# UNITED STATES PATENT AND TRADEMARK OFFICE

APPLICATION NO.	FILING DATE	FIRST NAMED INVENTOR	ATTORNEY DOCKET NO.	CONFIRMATION NO.
10/800,380	03/12/2004	Miguel Acosta	52028/RVW/A789	8844
23363	7590	02/07/2006	EXAMINER	
CHRISTIE, PARKER & HALE, LLP			ALI, SHUMAYA B	
PO BOX 7068			ART UNIT	
PASADENA, CA 91109-7068			PAPER NUMBER	
			3743

**Office Action Summary**

PRIOR ART  
FIG.2  
No. 638,434.  
J. MORGAN.

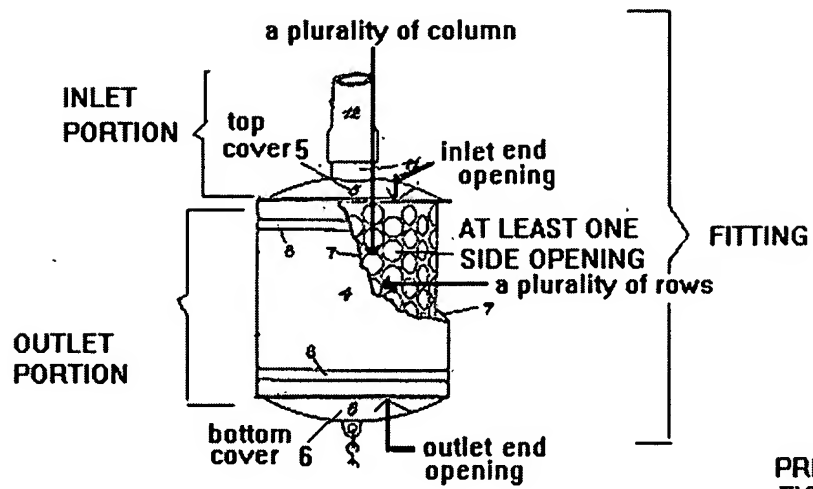
labeled figure 1, see attachment below has been provided to indicate all limitations of fitting are disclosed in the prior art reference to Morgan.

10. As to claim 1, Morgan discloses a fitting (see labeled fig.2 reference objects 4,11, and 12) for retrofitting to a tracheostomy tube comprising: an inlet portion (see labeled fig.2) for attachment to an outlet structure of the tracheostomy tube; and an outlet portion (see labeled fig.2) for extending from the outlet structure of the tracheostomy tube, wherein the outlet portion is connected to the inlet portion (see fig.2), and wherein the outlet portion comprises at least one side opening (see fig.2, page 1 lines 75-76, “perforated” reads on “openings”).

11. As to claim 2, Morgan discloses the tracheostomy tube fitting of claim 1, wherein the outlet portion comprises a plurality of rows of side openings and a plurality of columns of side openings (see labeled fig.2 reference object 4 has a plurality of side opening, see also page 1 lines 75-76)

(perforated casting 4 as depicted in fig.2 has row /column that are offset from an adjacent row/column).

14. As to claim 5, Morgan discloses a fitting (see labeled fig.2 reference objects 4,11, and 12) for retrofitting to a tracheostomy tube comprising: a hollow cylinder (fig.2 reference object 4; page 1 lines 83-84 recites “a sponge may be placed inside the casting 4”, therefore, the casting 4 is considered “hollow” since it has space to hold a sponge) having an inner diameter, an outer diameter (regarding “inner diameter” and “outer diameter”, a hollow cylinder inherently has an inner diameter consisting the perimeter inside the cylinder and an outer diameter consisting the perimeter outside of the cylinder) , an inlet end opening (fig.2, an inlet end opening is covered by a cover 5) and an outlet end opening (fig.2, an outlet end opening is covered by a cover 6) the cylinder further comprising: an inlet portion (see labeled fig.2), for attachment to an outlet structure of the tracheostomy tube, wherein the inlet portion comprises the inlet end opening (see labeled fig.2); and an outlet portion (see labeled fig.2) for extending from the outlet structure of the tracheostomy tube, wherein the outlet portion is connected to the inlet portion (see labeled fig.2), and wherein the outlet portion comprises the outlet end opening (see labeled fig.2) and at least one side opening (see fig.2, page 1 lines 75-76, “perforated” reads on “openings”) that extends from the inner diameter to the outer diameter (fig.2 depicts a “perforated” casting 4, therefore the perforation is considered

15. **As to claim 6, Morgan discloses the tracheostomy tube fitting of claim wherein the outlet portion comprises a plurality of rows of side openings (see labeled fig.2) that extend from the inner diameter to the outer diameter and a plurality of columns of side openings (see labeled fig.2) that extend from the inner diameter to the outer diameter**

16. **As to claim 7, Morgan discloses the tracheostomy tube fitting of claim 6, wherein each row is offset from an adjacent row and wherein each column is offset from an adjacent column (perforated casting 4 as depicted in fig.2 has row /column that are offset from an adjacent row/column).**

*FIG. 6.* Prior Art  
COLAVITA  
2,491,647

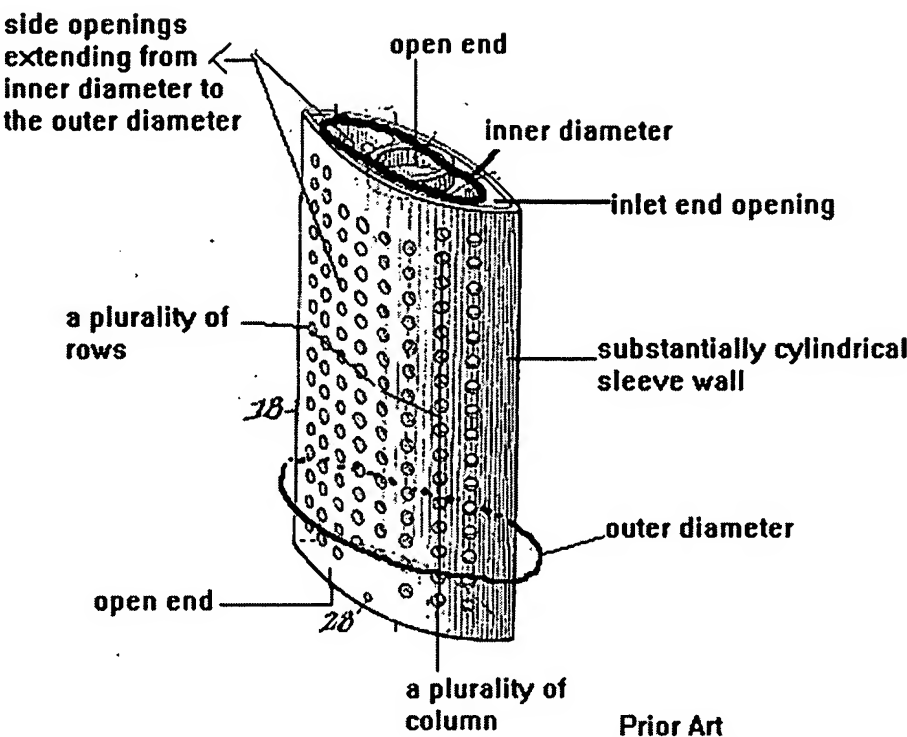
20. As to claim 13, Colavita discloses a tracheostomy tube (figs. 1-9, reference object 10, see also col.2 line 8) comprising: an inlet structure (12) for insertion into a patient's trachea; and an outlet structure (18) for extending from an opening in the patient's neck, wherein the outlet structure is connected to the inlet structure (see fig.2), and wherein the outlet structure comprises an inner diameter, an outer diameter (regarding "inner diameter" and "outer diameter", outlet structure 18 has is considered a hollow tube, see labeled fig.6 and a hollow tube inherently considered to have an inner and outer diameter) , an inlet end opening (see labeled fig.6, reads on "open top end", see col.3 lines 4-5) and at least one side opening (see fig.2) that extends from the inner diameter to the outer diameter (see labeled fig.6),

21. As to claim 14, Colavita discloses the tracheostomy tube of claim 13, wherein the outlet structure comprises a plurality of rows (see labeled fig. 6) of side openings that extend from the inner diameter to the outer diameter and a plurality of columns (see labeled fig.6) of side openings that extend from the inner diameter the outer diameter.

of the outlet structure (see **fig.6**), the fitting comprising: a sleeve (18) having opposite open ends (see labeled **fig.6**) and having a substantially cylindrical sleeve wall (see labeled **fig.6**) through which is defined at least one sleeve wall opening (see **fig.2**), the sleeve being arranged to be engaged at one end see (**fig.1**, “one end” being connected to a tube 10) thereof around the outlet structure of the tracheostomy tube with the other end (**fig.1**, “other end” opposite to “one end”) of the sleeve spaced beyond the tube end air flow aperture relative to the tracheostomy tube and with the sleeve wall opening positioned toward the tracheostomy tube from the other end of the sleeve in effective air flow communication with the tube end air flow aperture (see **figs.2 and 3**).

23. As to **claim 20**, Colavita discloses an occlusion preventing tracheostomy tube having an outer end structure (**fig.3, 12**) which is located outside a trachea in use of the tracheostomy tube, the outer end structure having an air flow aperture (“a tube end air flow aperture” is considered the end opening of tube 12 that is in communication with 16 allowing mucous to flow into 16, see col.3 lines 27-35) at an outer end (where 18 connects the end opening of tube 12) of the tube which lies substantially in a plane transversely of the tracheostomy tube (see **fig.1**) and also defining at least one air flow opening laterally (see **fig.2**) into the tracheostomy tube at a location along the outer end structure of the tracheostomy tube from the air flow aperture (see labeled **fig.6**).

29. **As to claim 19, Colavita discloses** the occlusion preventing fitting according to claim 18 in which plural openings (see fig.2) are defined through the sleeve wall at locations spaced around the sleeve (see labeled fig.6), **however does not disclose the sleeve is “flexible”**. As to “flexible”, the applicant has not established criticalities regarding why a “flexible” sleeve is critical to the invention. **Therefore, it would have been obvious to one of ordinary skills in the art to consider the constructive material of the sleeve as a matter of design preference, therefore further consider Colavita’s sleeve 18 which is fashioned from perforated sheet material (see col.2 lines 56-57) to meet the “flexible” limitation.**
